**Wildwood Park Welcome Center ITB  
Addendum No. 02**

<b>Project Name: Wildwood Park Welcome Center</b>	<b>Project No.:</b> RFP#21-22-54
<b>Prepared By: Mark Nottingham</b>	<b>Date:</b> 6-30-2022

**L0.1**

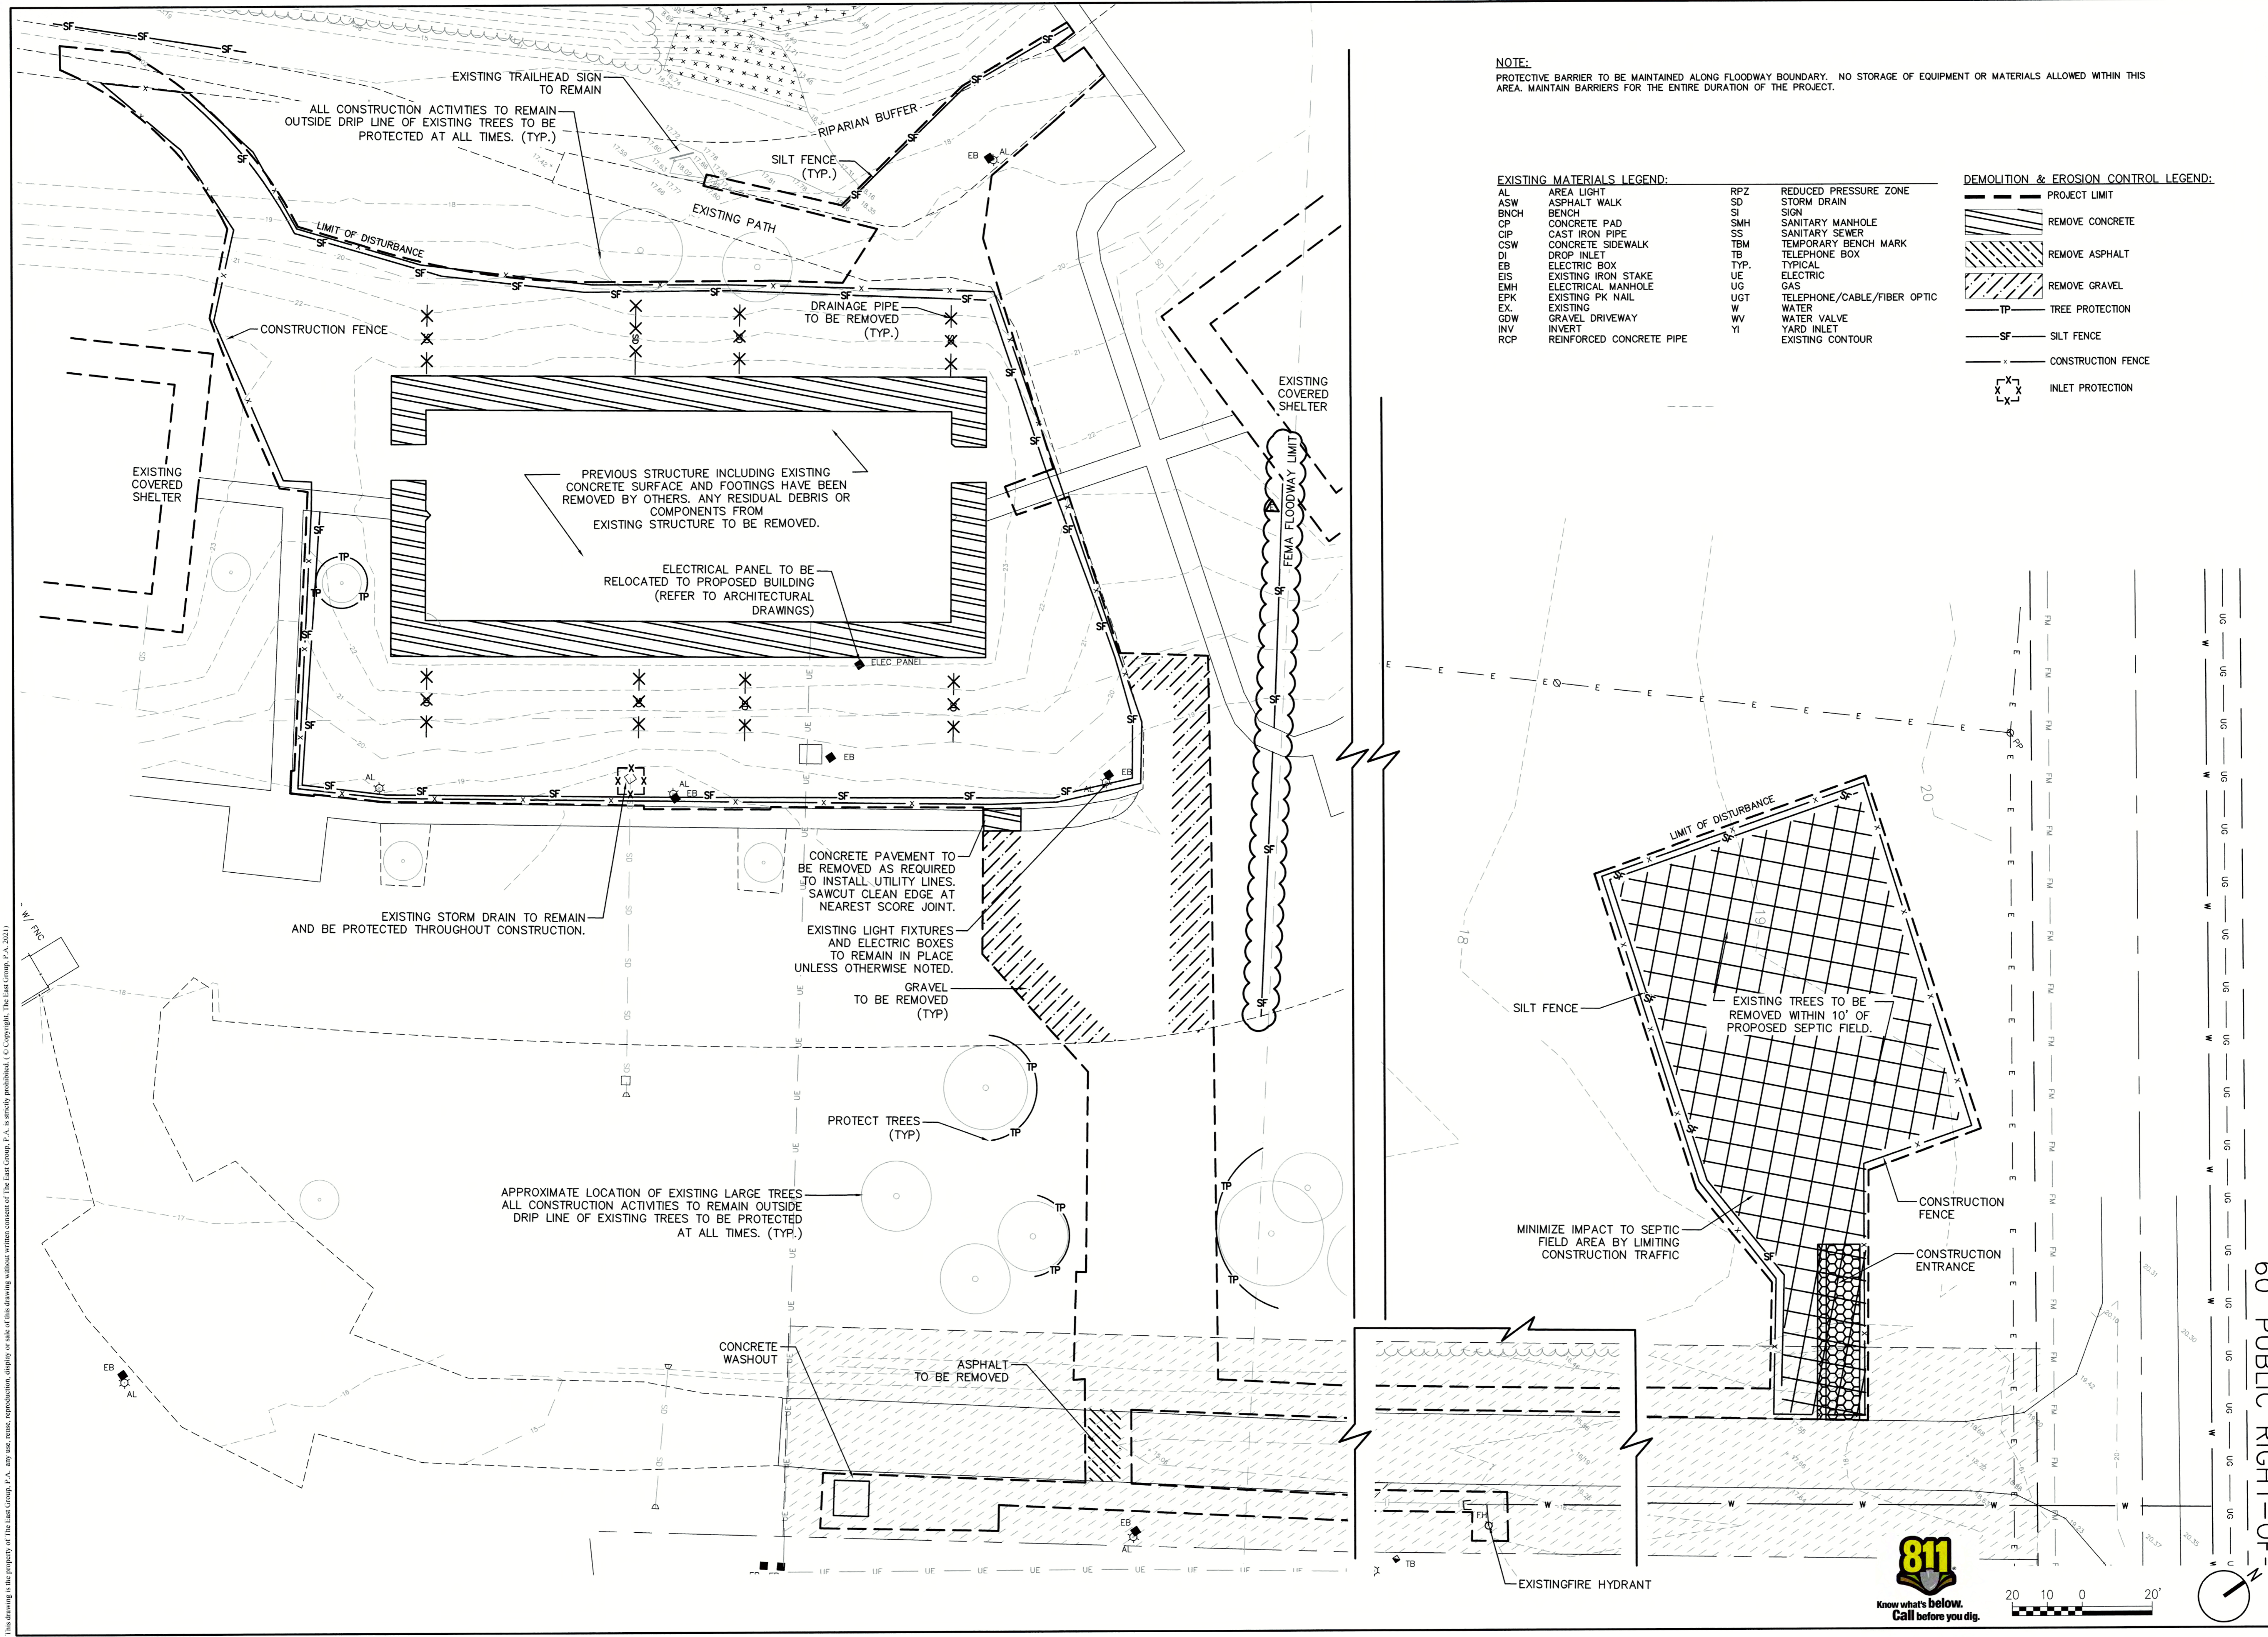
- Review comments have dictated changes to four of the plan sheets (L0.1, C3.1, C3.2, C4.1) Revised sheets are attached.
